# MAPLE SHADE ADDITION

RE: SUB 2000-55 -- Final Plat of Maple Shade Addition

At the regular meeting of the Subdivision Committee of the Metropolitan Area Planning Commission on Thursday, August 16, 2001, the above captioned plat was considered. The action of the Committee was to approve the final plat, subject to the following:

**CASE NUMBER:** SUB 2000-55 -- MAPLE SHADE ADDITION

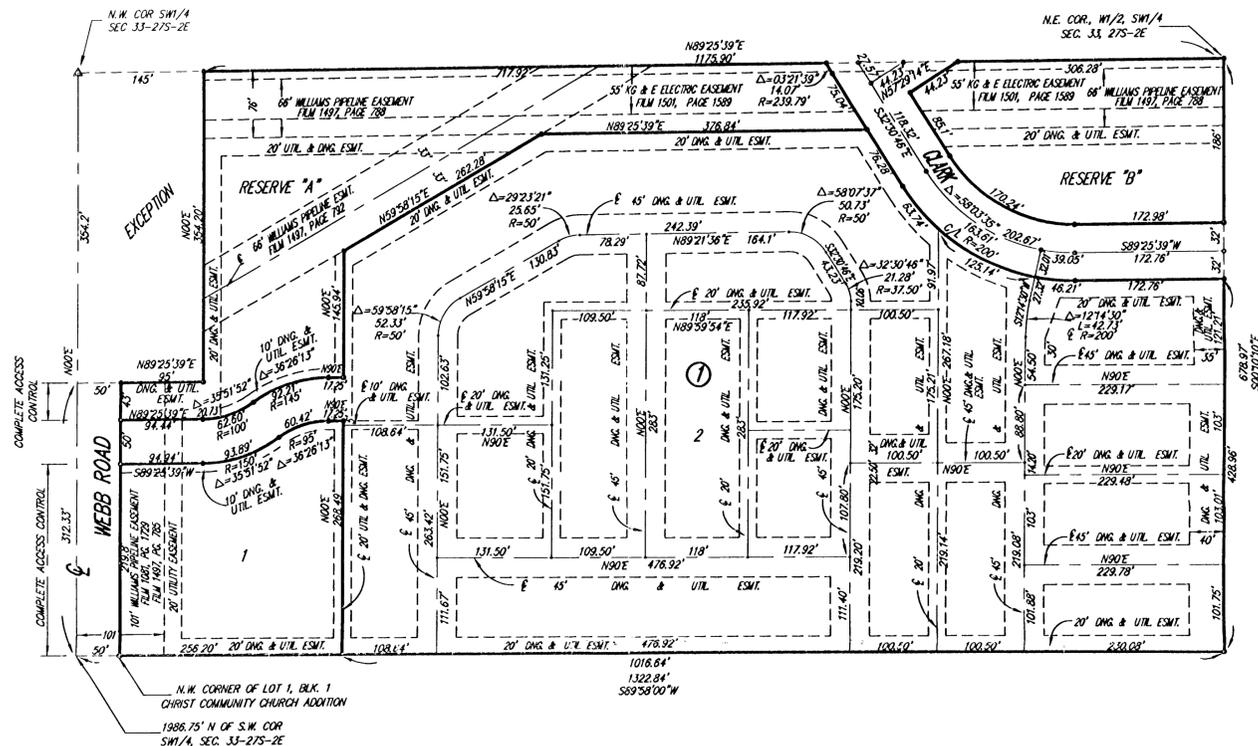
- F. City Engineering needs to comment on the need for any additional guarantees or easements. An off-site drainage easement is requested unless this Addition is platted concurrently with Brentwood South Addition to the east. A drainage guarantee is required.

- G. City Engineering needs to comment on the status of the applicant's drainage plan. On-site detention will be needed on the final drainage plan.
- H. The plattor's text shall include ownership and maintenance responsibilities of the reserves.

- M. The applicant shall submit a copy of the instrument which establishes the pipeline easements on the property, which verifies that the easements shown are sufficient and that utilities may be located adjacent to and within the easements.

- N. The applicant's agent shall determine any setback requirements for the pipelines by researching the text of the pipeline agreements. If a setback from the pipeline easements is provided for in the pipeline easement agreements, it shall be indicated on the face of the plat.

- O. The Applicant shall guarantee the paving of the proposed streets. The guarantee shall also provide for sidewalks on the south side of Clark.
- P. The paving guarantee shall include the installation of a temporary turnaround at the terminus of Clark at the plat's east line unless the abutting street to the east has been constructed. The temporary turnaround shall be established by separate instrument.

- Q. City Fire Department should comment on the plat's street names. Stoneybrook should be revised to "Clark".

- Q. City Fire Department should comment on the plat's street names. Stoneybrook should be revised to "Clark".

The street name has been revised as requested.
- R. A Protective Overlay Certificate shall be submitted to MAPD prior to City Council consideration, identifying the approved Protective Overlay (referenced as P-O #83) and its special conditions for development on this property.
- S. The plat's text shall include language that a drainage plan has been developed for the plat and that all drainage easements, rights-of-way, or reserves shall remain at established grades or as modified with the approval of the applicable City or County Engineer, and unobstructed to allow for the conveyance of stormwater.

The street name has been revised as requested.
- R. A Protective Overlay Certificate shall be submitted to MAPD prior to City Council consideration, identifying the approved Protective Overlay (referenced as P-O #83) and its special conditions for development on this property.
